REPLACEMENT DWELLING @ PEN Y COED
 ERYRYS FOR SHARON ROBINSON

APPLICATION NO: 15/2016/0009/PF

PROPOSAL: Erection of replacement dwelling

LOCATION: Pen Y Coed Eryrys Mold

DWG. TITLE:
PROPOSED ELEVATIONS

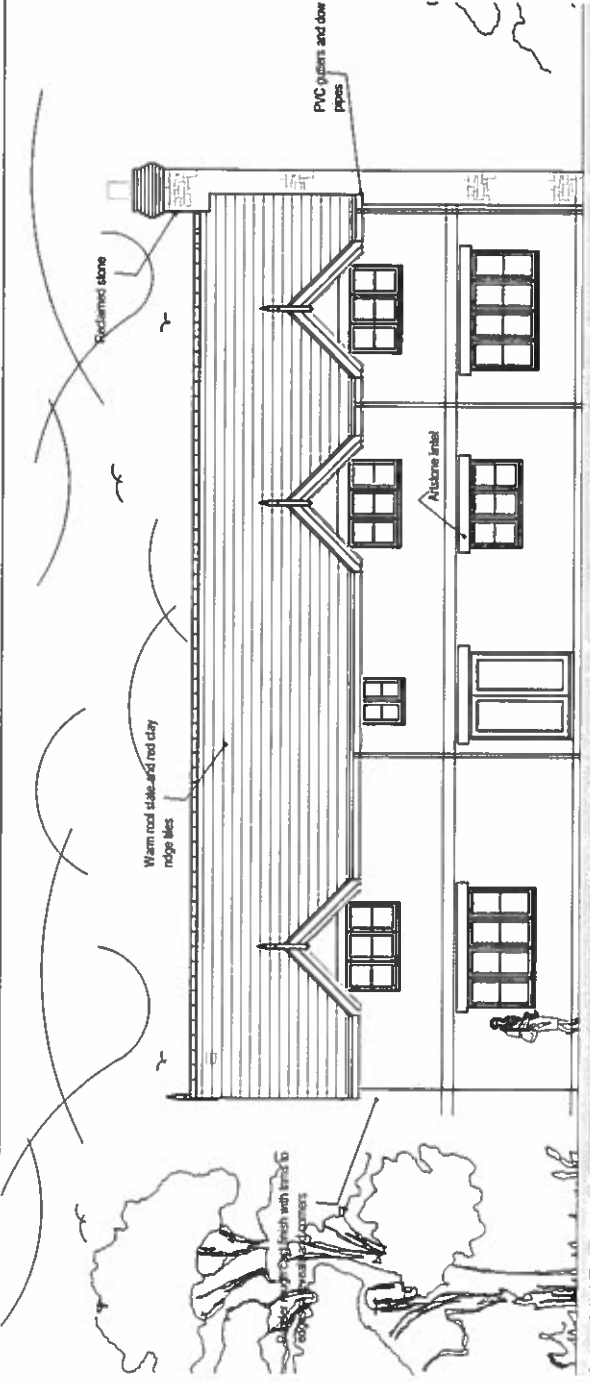
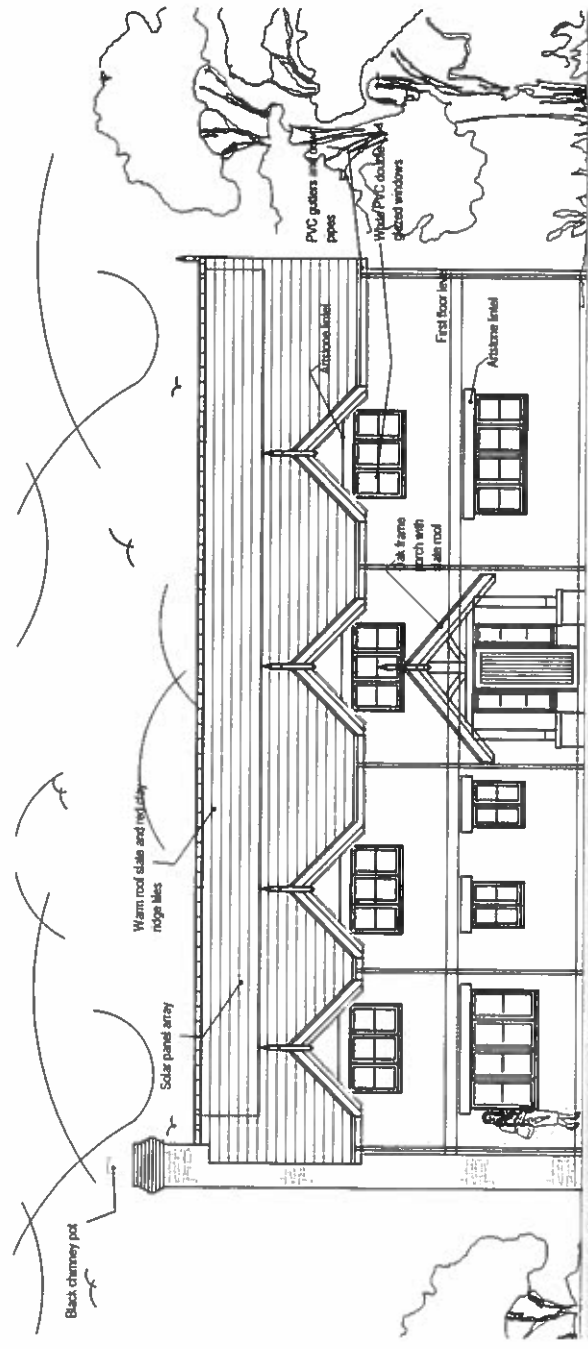
“Council felt the development was more than 50% bigger than original dwelling, and it contravened the regulations of not allowing gable end facing developments on the road side – as other properties have had to adhere to only 100 yards away. This site was originally two fields, and then hedges and boundaries were removed to form one site for development, before planning permission was asked for. This means the plot is now far bigger than the foot-print of the original plot. Not Supported.”

Scale of proposals excessive. Orientation of dwelling is not acceptable.

10/03/16 Rev.C
After discussion with Planning officer :-
Floor plan area reduced, ridge height reduced
Brick arches over openings changed to stone lintels
Dwelling relocated and rotated to face road on site

SITE AND LOCATION PLAN
DWG. TITLE:

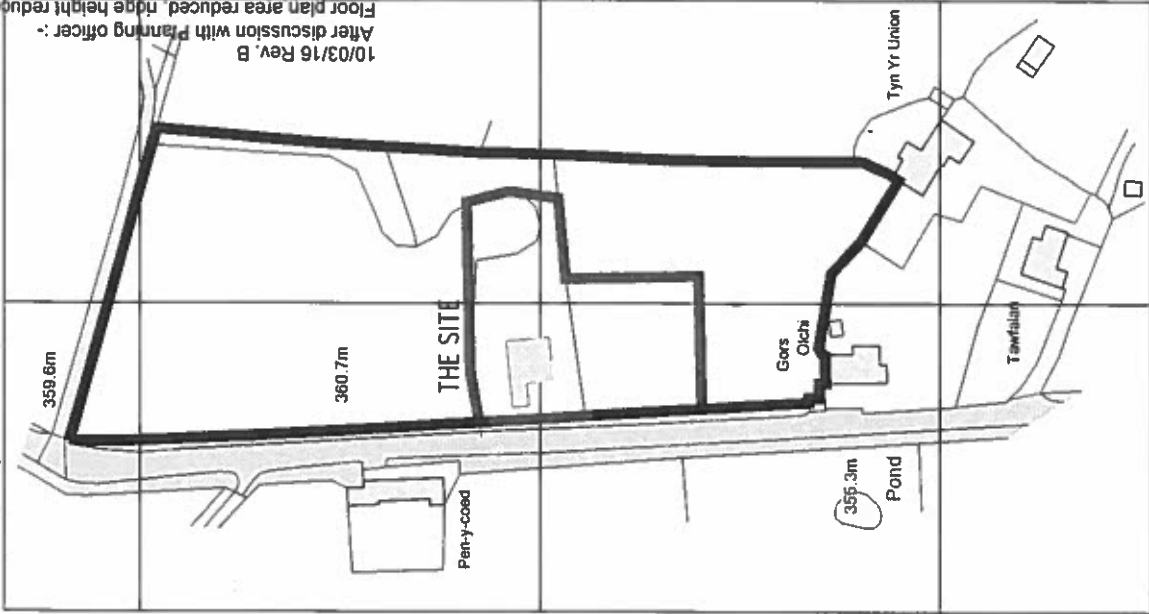
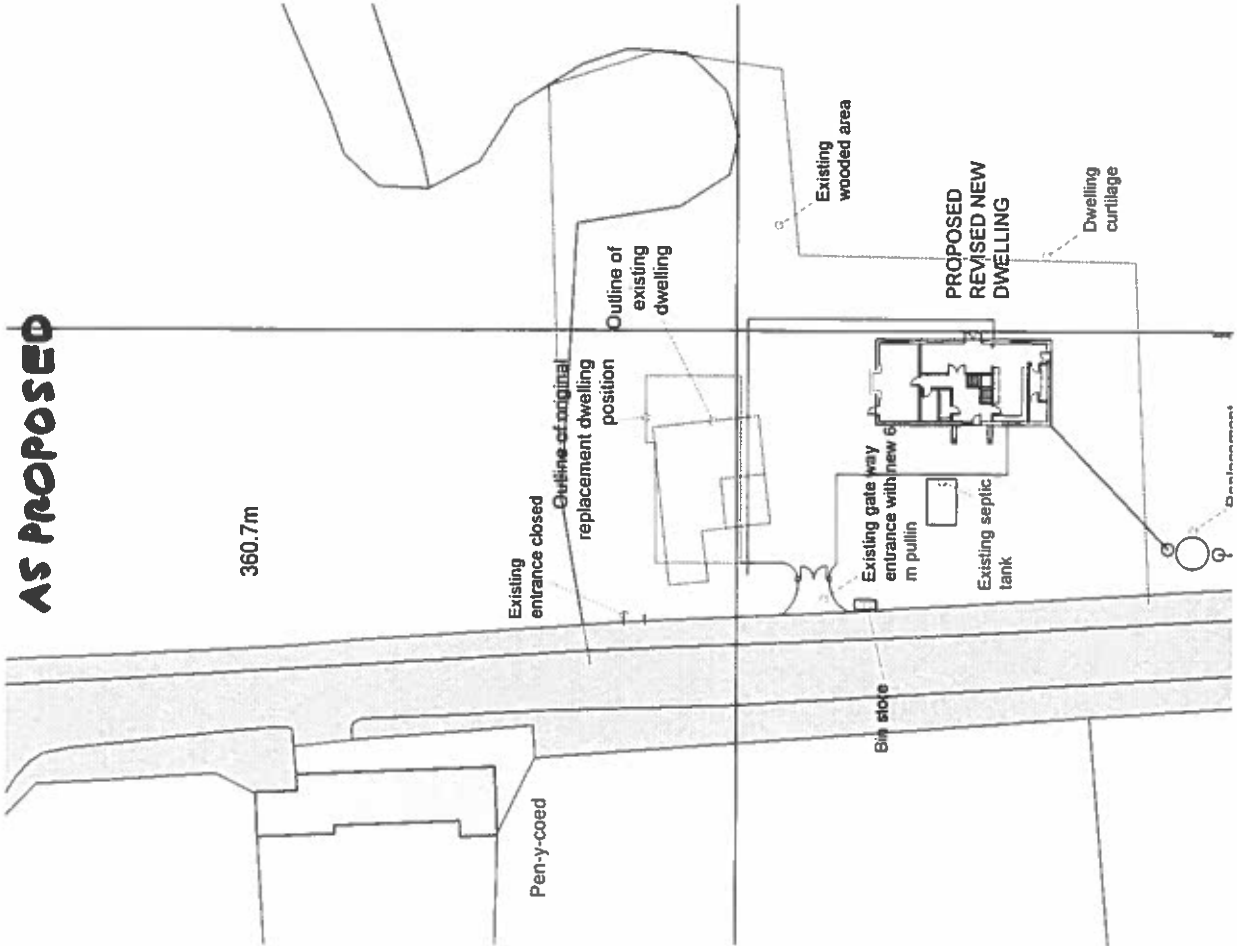
The house has now been moved. This site was two fields - then just before planning was applied for all the hedges were ripped out to make one bit field- is this allowed? The new house is far bigger than 50% of the old - which has been demolished - before planning was even applied for. The good soil has already been scrapped away from a good growing field to now be a building site. The septic tank is too close to the road.”

- 1.5.1 Following the initial objection of the Community Council, and the comments of the AONB Committee, the applicants have amended the site layout to locate the dwelling nearer existing development, and they have re-orientated the siting to face the dwelling onto the road, and reduced the scale of the proposal.

After discussion with Planning officer :-
10/03/16 Rev. B
Floor plan area reduced, ridge height reduced
Brick arches over openings changed to stone lintels
Dwelling relocated and rotated to face road on site
